Annex 1 - LirIC response to Initial Project Assessment of the Third Cap and Floor Window for Electricity Interconnectors

1. Ofgem relies on a Socio-Economic Welfare modelling output which is flawed

Figure 5 - Change in wholesale price with LirIC added, ARUP modelling and LCP replica of ARUP modelling

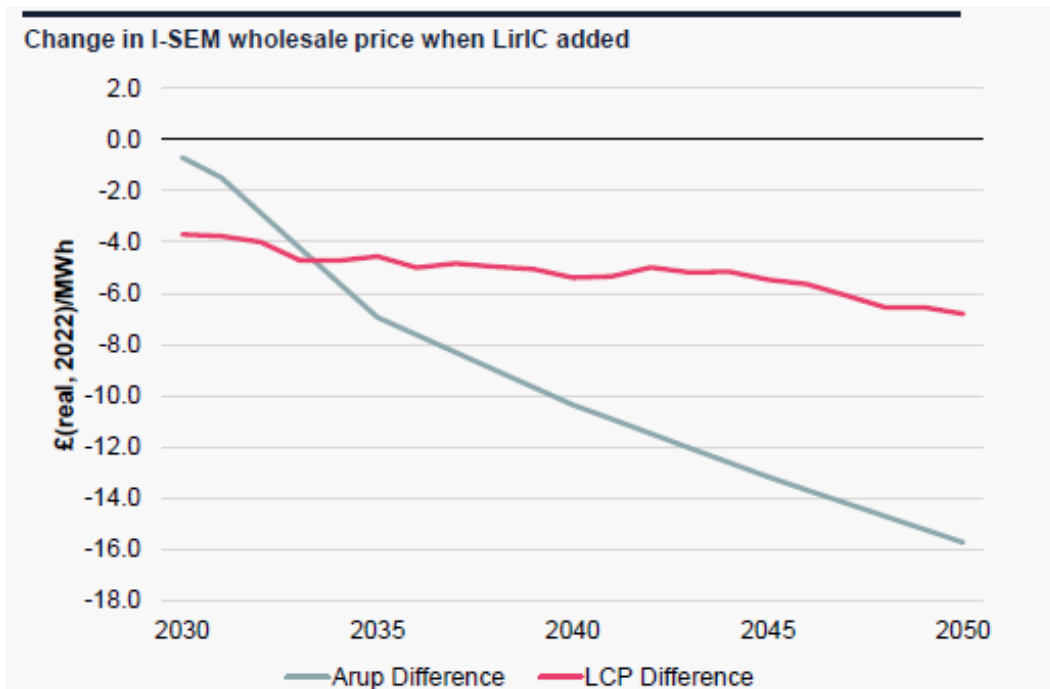
Investigation into the difference in congestion revenues when LirIC was added looked at flows and prices. While the difference on flows between the LCP and ARUP modelling are relatively small (slide 13, Annex 2), the difference in SEM wholesale prices was significant, with ARUP's model showing LirIC led to a sharp reduction in SEM wholesale prices, particularly into the future.

It is this price reduction that drives the lower congestion revenues in the ARUP modelling. In comparison by 2050 in ARUP's modelling SEM prices are £16/MWh lower when LirIC is added than in LCP's model (Figure 5).
